**AMENDMENTS TO THE DRAWINGS**

**REMARKS**

ANNOTATED SHEET

**FIG.10**

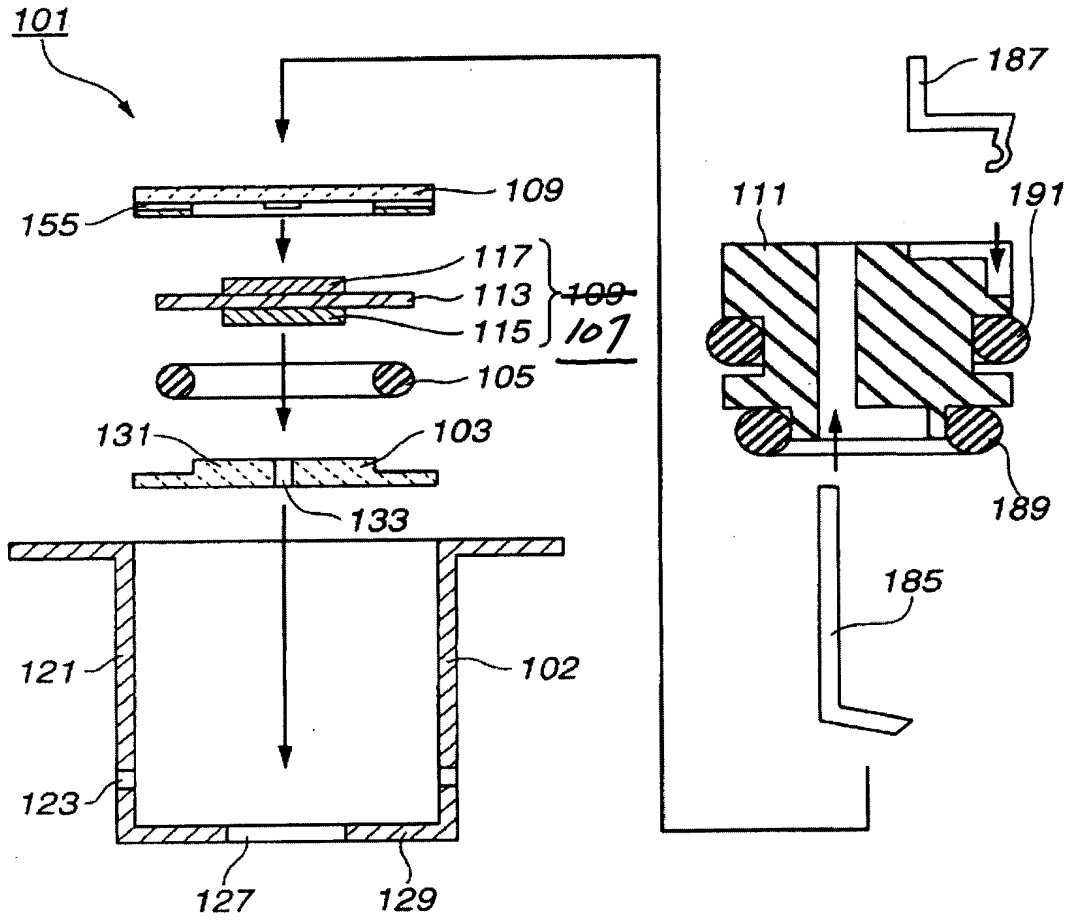
Two (2) replacement drawing sheets (Figs. 10, 11 and 17) are submitted herewith. Fig. 10 has been amended to correctly identify sensor element 107. Fig. 17 has been corrected so as to be designated "PRIOR ART". Fig. 11 is unchanged.

The Examiner has objected to the drawings because of various informalities as outlined on pages 2 and 3 of the instant Office Action. Applicants hereby amend FIGS. 10 and 17 and amend the specification in order to correct the noted deficiencies.
